Monticello Nuclear Generating Plant
Docket No. 50-263
Renewed Facility Operating License No. DPR-22

Prairie Island Nuclear Generating Plant, Units 1 and 2
Docket Nos. 50-282 and 50-306
Renewed Facility Operating License Nos. DPR-42 and DPR-60

Response to a Request for Additional Information RE: Xcel Energy Amendment Request to Create a Common Emergency Plan and Emergency Operations Facility for Monticello and Prairie Island (EPID: L-2021-LLA-0210)

**RESPONSE TO A REQUEST FOR ADDITIONAL INFORMATION RE: XCEL ENERGY
AMENDMENT REQUEST TO CREATE A COMMON EMERGENCY PLAN AND
EMERGENCY OPERATIONS FACILITY FOR MONTICELLO AND PRAIRIE ISLAND**

Figure B-1, TSC Organization

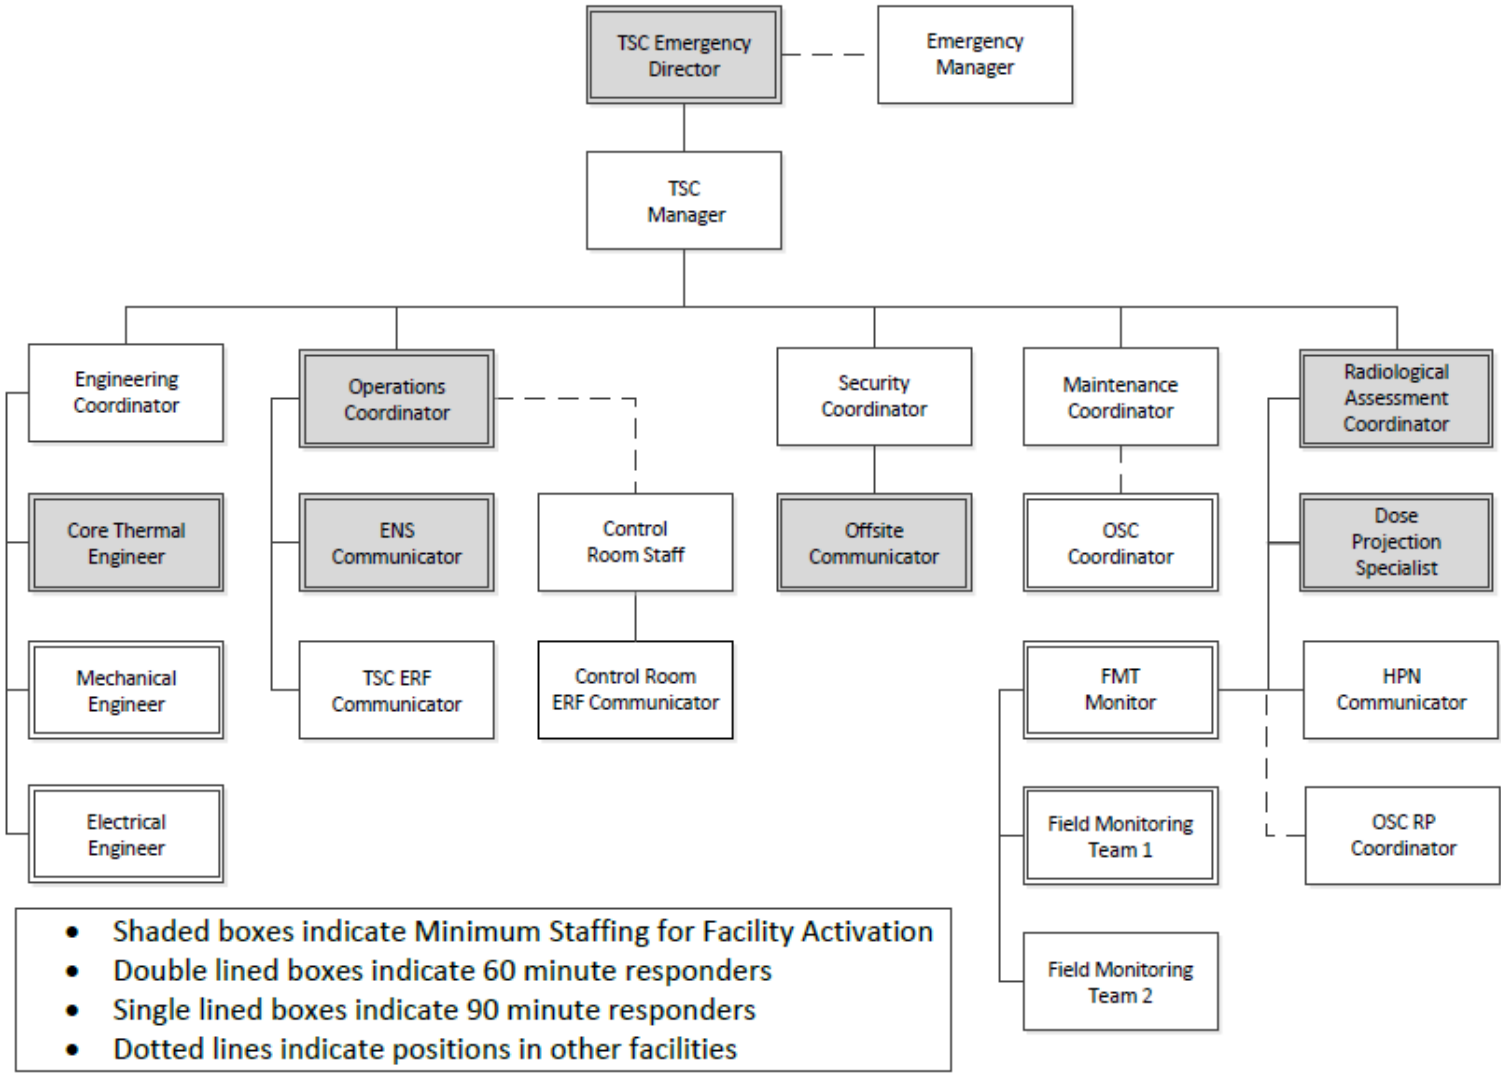
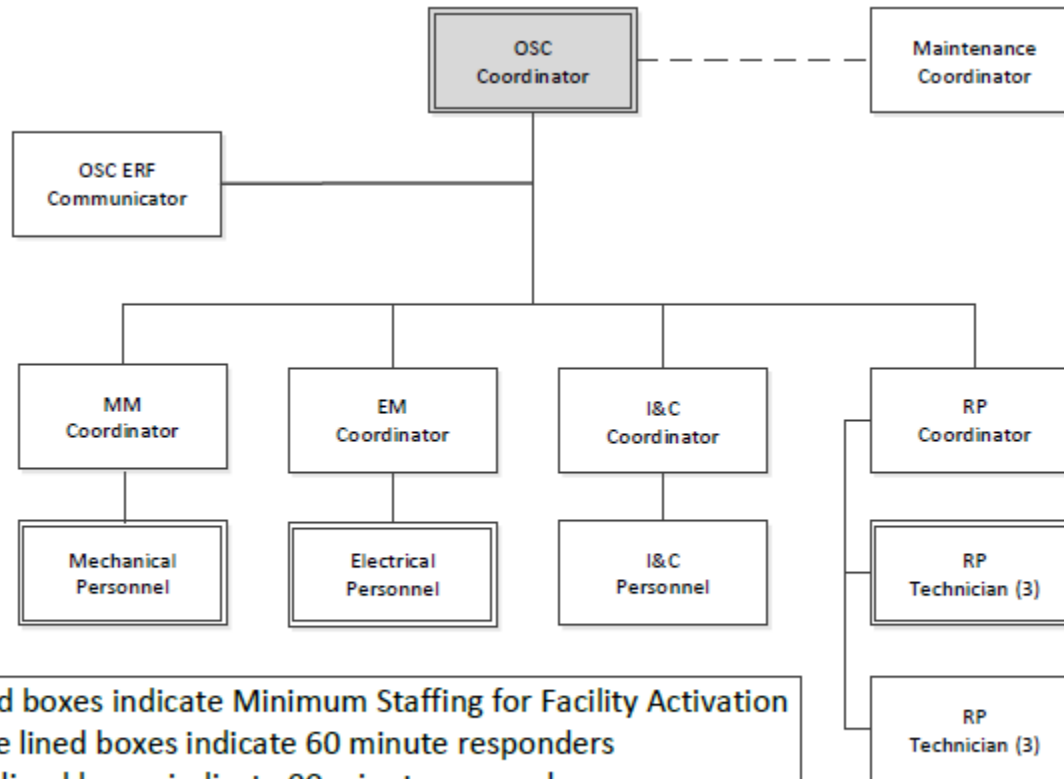
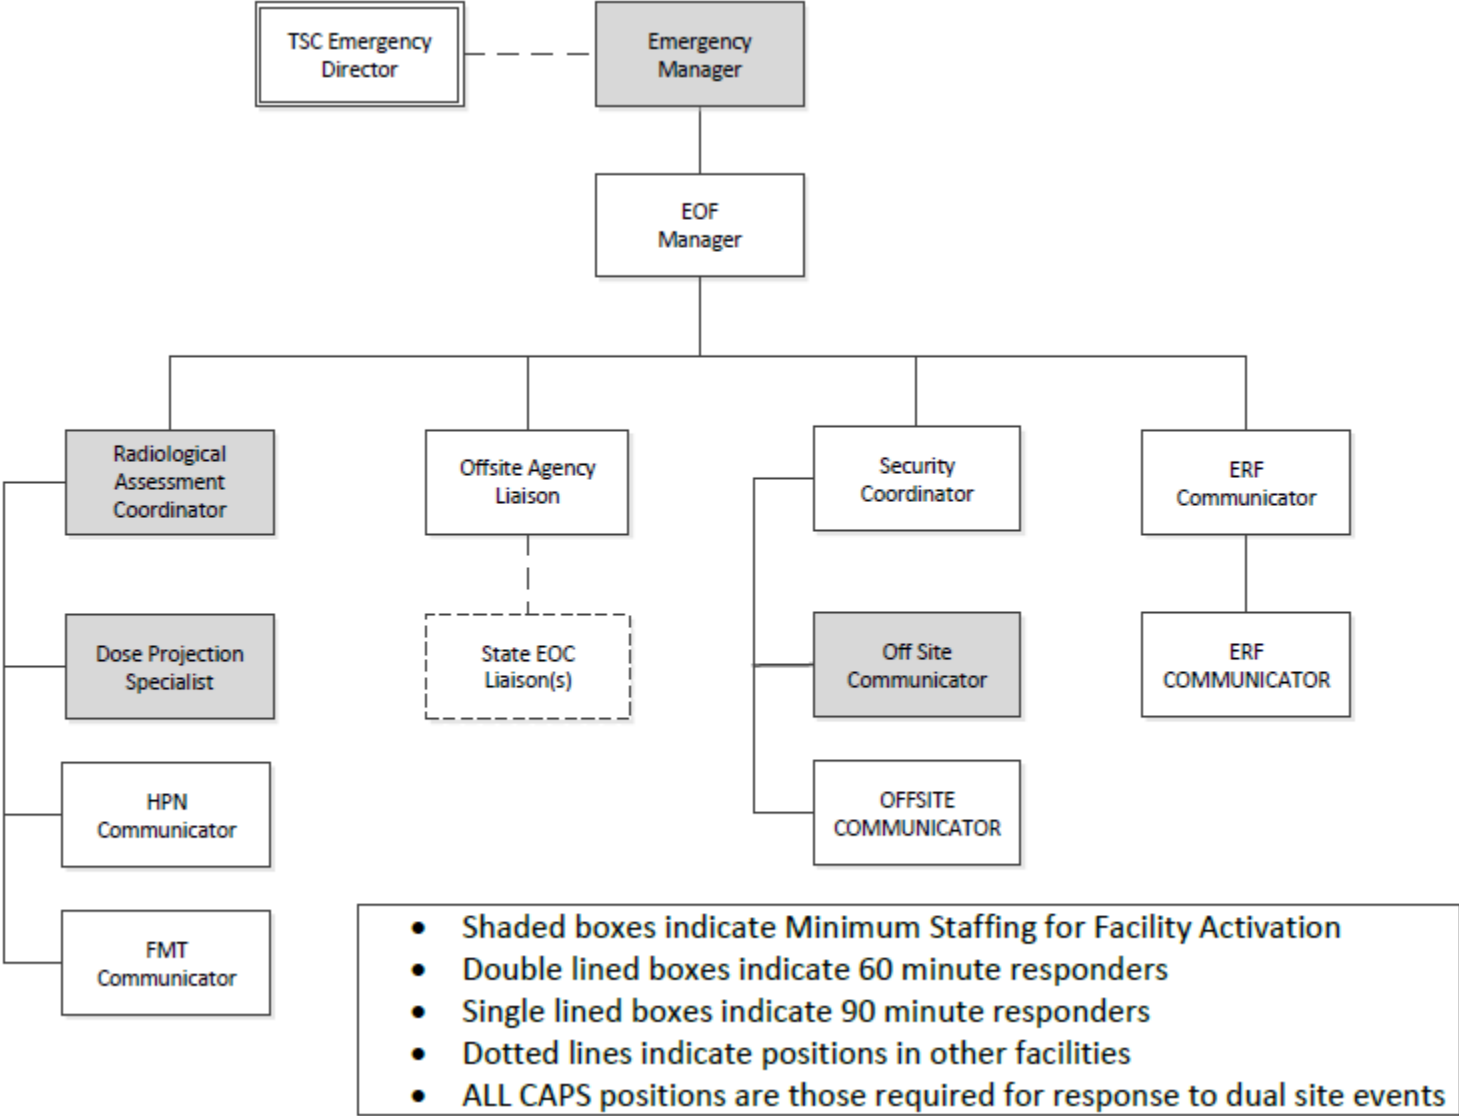
However, Figures B-1, “TSC Organization,” B-2, “OSC organization,” and B-3, “EOF Organization,” show minimum staffing for the respective facility activation that is not consistent with the Xcel Table B-1.

Request: Provide justification as to how these facilities can be considered staffed for activation with the level of staffing below the Xcel Table B-1 minimum staffing.

The proposed SEP provides for staffing of the required functions within 60 and 90 minutes of an Alert or higher classification to relieve and support the on-shift staff and effectively implement the Emergency Plan. The positions listed in SEP Table B-1 include the minimum on-shift and augmented staffing as identified in NUREG-0654, Revision 2, Table B-1 as well as the minimum staff for facility activation as identified in Figures B-1, B-2, and B-3.

SEP Figures B-1, “TSC Organization,” B-2, “OSC Organization,” and B-3, “EOF Organization,” are intended to show the required staffing and applicable response times for each position. The positions in each figure annotated as “minimum staffing” represent a subset of the facility

For the TSC, the TSC Emergency Director, Core Thermal Engineer, Radiological Assessment Coordinator, Dose Projection Specialist, Offsite Communicator, and ENS Communicator positions in the Technical Support Center (TSC) will relieve the control room staff of classification, core damage assessment, emergency exposure authorization and NRC notification, responsibilities. The change removes the ERF Communicator as a minimum staffing position for activation of the TSC as this position is not required for performance of a command-and-control function. Additionally, the proposed change provides a Dose Projection Specialist as a minimum staffing position to support performance of dose assessment and PAR development in that facility. A comparison of the current Emergency Plans’ and proposed SEP’s TSC minimum staffing for activation is provided in the following table.

For the OSC, the proposed SEP maintains the OSC Coordinator as the position responsible for relieving the Control Room of responsibility for oversight of repair and corrective actions. The proposed change removes the Radiation Protection Coordinator from the facility minimum staffing for activation and extends the response time to 90 minutes. The OSC Coordinator and the TSC Radiological Assessment Coordinator, both 60-minute responders are able to maintain oversight of augmented Radiation Protection Technicians until the OSC RP Coordinator arrives. This change is in accordance with NUREG-0654 Revision 2. A comparison of the current Emergency Plans’ and proposed SEP’s OSC minimum staffing for activation is provided in the following table.

For the EOF, the proposed SEP identifies the Emergency Manager, Radiological Assessment Coordinator, Dose Projection Specialist, and Offsite Communicator in the EOF as the positions that will relieve the TSC of responsibility for offsite response coordination, PARs, dose assessment, and state/local notifications. By establishing this minimum command-and-control staffing needed for facility activation, the potential for relief of the TSC personnel of these responsibilities could occur sooner than the 90-minute augmented response time. The proposed change removes the ENS Communicator from the EOF staffing as this function will remain in the TSC. Like the TSC proposed change, the ERF Communicator position is removed from minimum staffing for facility activation, however, it remains a 90-minute response position in the EOF. Finally, the proposed change provides for a Dose Projection Specialist as a minimum staff position to support performance of dose assessment and PAR development in that facility. A comparison of the current Emergency Plans' and proposed SEP's EOF minimum staffing for activation is provided in the following table.
